**AGENDA**  
**EAST GOSHEN TOWNSHIP**  
**CONSERVANCY BOARD MEETING**

Date: 9/2/2021  
To: Conservancy Board  
From: Mark Gordon, Township Zoning Officer   
Re: Malvern Institute Land Development / Landscaping Plan

Re: Preliminary Land Development - Malvern Institute 2nd Story Building Addition (Revised)  
# East Goshen Township – LD-07-21-16804

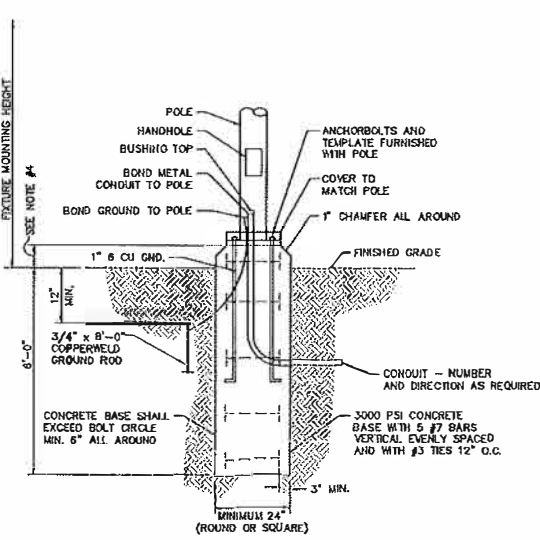
3. The Township should verify that the design of the proposed outdoor lighting plan (Sheet 10) conforms to Township ordinance requirements. The illumination should be directed inward from the periphery of the site and be oriented to reduce glare and visual impact on the adjoining roadways and land uses.

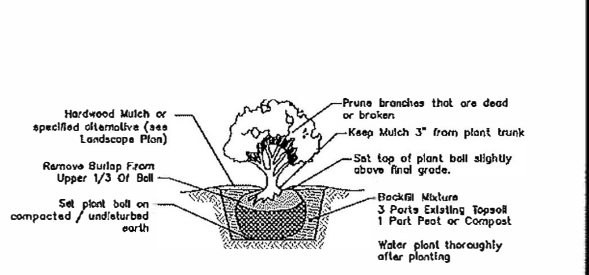
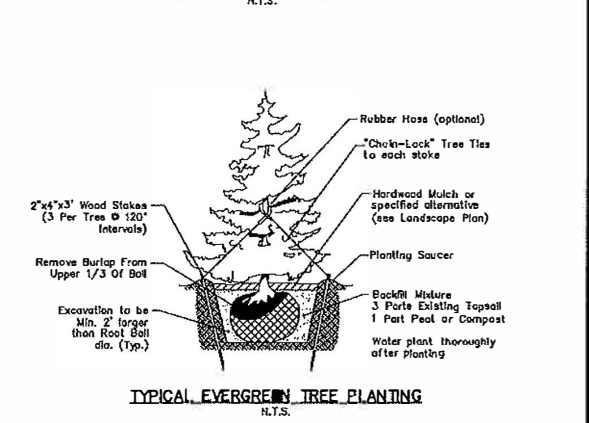
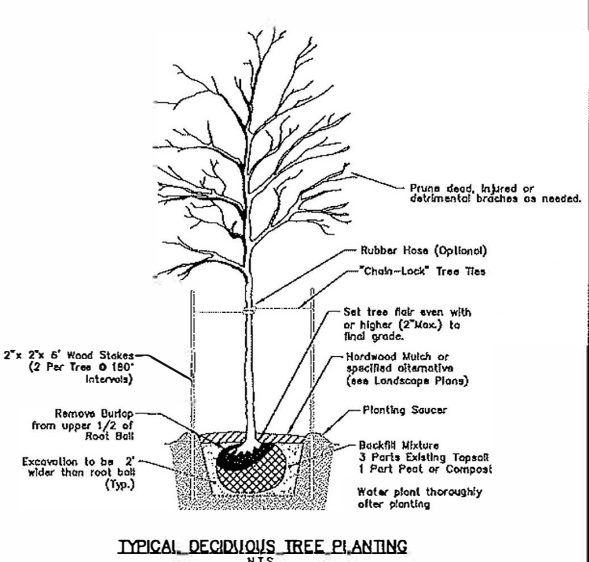
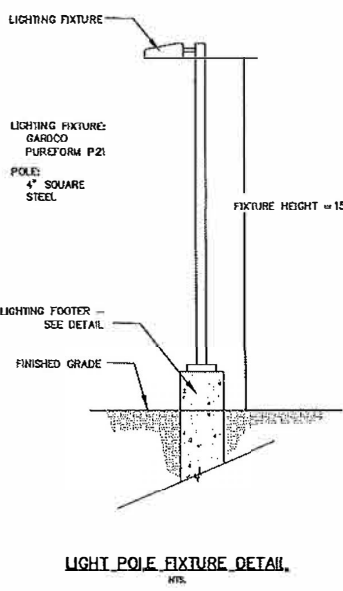
A landscaping plan (Sheet 9) and details (Sheet 11) have been provided. The proposed landscaping is robust and appears to meet the intent of the Code and the Decision and Order. We will defer to the Conservancy Board for additional comments.

A landscaping plan (Sheet 9) and details (Sheet 11) have been provided and the evergreens are specified as 10-feet in height. The proposed landscaping is robust and appears to meet the intent of the Code and the Decision and Order. We will defer to the Conservancy Board for additional comments.

- a. The fence and landscaping are indicated as required.
- b. It may be appropriate to substitute a more deer resistant species for the proposed mountain laurel; please review with the Conservancy Board.
- c. We will defer to the Conservancy Board of additional comments.
- d. The applicant shall submit the fencing plan to Willistown Township for review and comment and a determination if any permits are required.

4. While we acknowledge that Sheet 9-Landscape Plan depicts that extensive landscaping will be provided along the northern, western, and southern parcel boundaries (west of the existing floodplain area), we recommend that the applicant and Township consider planting additional trees, shrubs, and ground cover in areas currently covered by lawn within and adjacent to the parking areas. [Landscapes3](#) recommends that developments in the **Suburban Landscape** include extensive landscaping in parking areas (page 39).

1. The applicant shall provide additional landscaping within the parking lot island and along the western and eastern side of the parking areas, similar to what they propose along the northern side of the parking area.
